**ZONING AMENDMENT
& SUBDIVISION STAFF REPORT****Date: April 4, 2013****APPLICANT NAME**

D.E.H. Subdivision

Subdivision to create 1 lot, and Zoning to rezone the site from R-1, Single-Family Residential, to B-1, Buffer Business, to allow an office building.

SITE PLAN

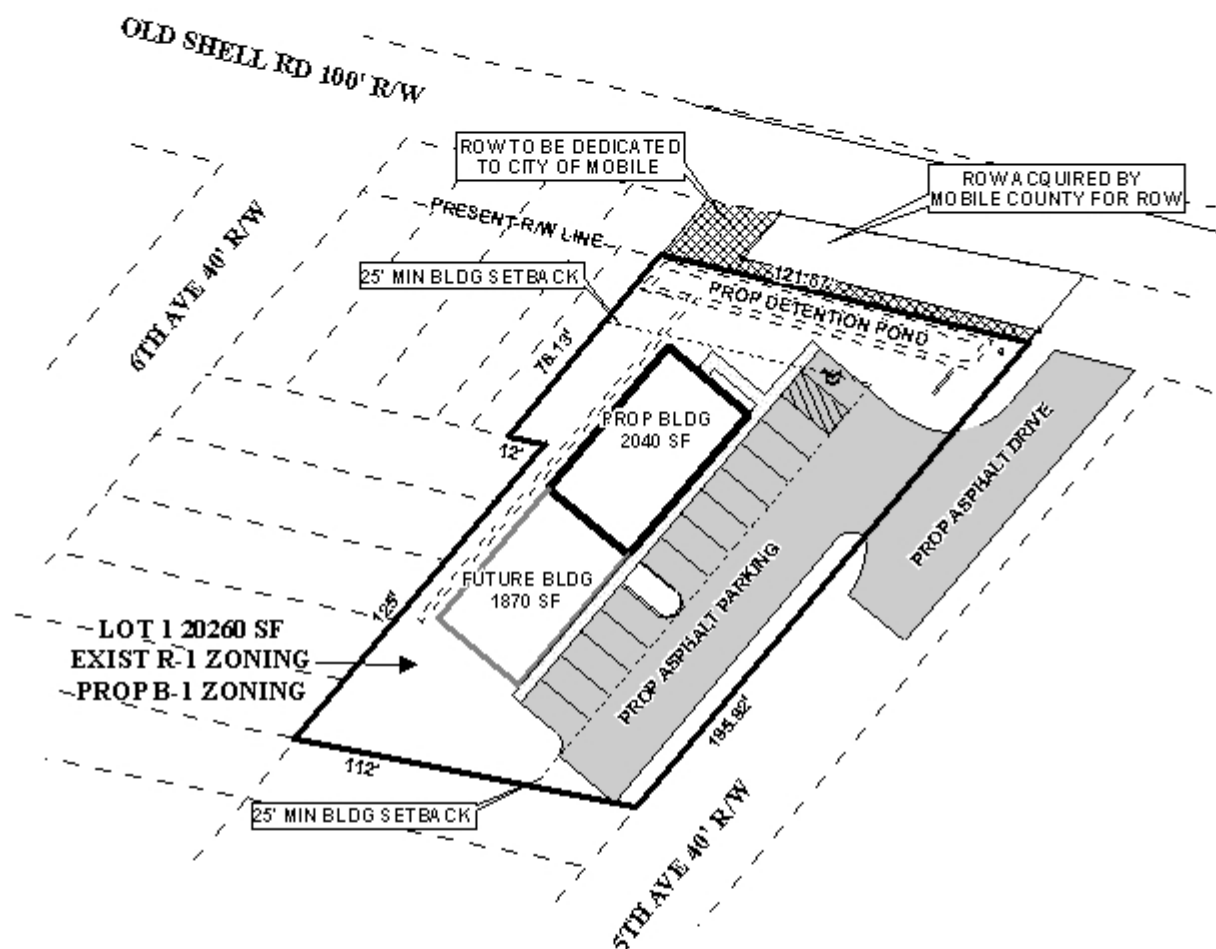
The site plan does not illustrate a residential buffer at all, however there is a note stating that the site will comply with Section V.A.8. of the Subdivision Regulations regarding the provision of a residential buffer. It also appears that the proposed structure would not encroach into the 10' building setback required adjacent to residentially zoned or utilized properties.

The site plan includes a note stating that curbside pickup will be utilized, making the provision of a properly screened dumpster unnecessary.

The site plan states that the required amount of tree plantings and landscaping will be provided, however, the trees are not illustrated on the site plan. Furthermore, the landscaped area calculations are provided in acres, and should be given in square feet.

The preliminary plat states the Lots 1-5 of the West Mobile Terrace Subdivision will be included in the currently proposed Subdivision; however it appears that the East ½ of Lot 6 is also included. This parcel, while illustrated as part of the Subdivision, there is no authorization from the owner of the East ½ of Lot 6. This portion should be removed from the proposed development, or owner authorization should be submitted.

The site fronts onto Old Shell Road, a major street, which should have a right-of-way of 100'. The site plan illustrates dedications to the City of Mobile to provide a compliant 50' from the centerline. The site also fronts onto an unopened right-of-way associated with 5th Avenue. The plat illustrates 5th Avenue as having a right-of-way of 40'. The applicant has illustrated an increased minimum building setback of 30' to provide a possible 25' from the centerline of 5th Avenue should it be constructed. Instead of proposing an increased setback, dedication should be made to provide 25' from the centerline of 5th Avenue. The proposed site plan illustrates an existing curb cut from Old Shell Road which is in the 5th Avenue right-of-way. A note on the site plan indicates that the applicant wishes to access the proposed lot through this existing curb cut and be denied direct access to Old Shell Road. The applicant states that the roadway along 5th Avenue will be constructed to City of Mobile specifications. If approved, a note should be placed on the Final Plat limiting the lot to one curb cut to 5th Avenue and denied direct access to Old Shell Road, with the size, design, and location of the curb cut to be approved by Traffic Engineering and conform to AASHTO standards.

The 25' minimum building setback line is illustrated along Old Shell Road, with a 30' minimum building setback line along 5th Avenue as mentioned previously. If approved, both setback lines should be labeled and illustrated on the Final Plat.
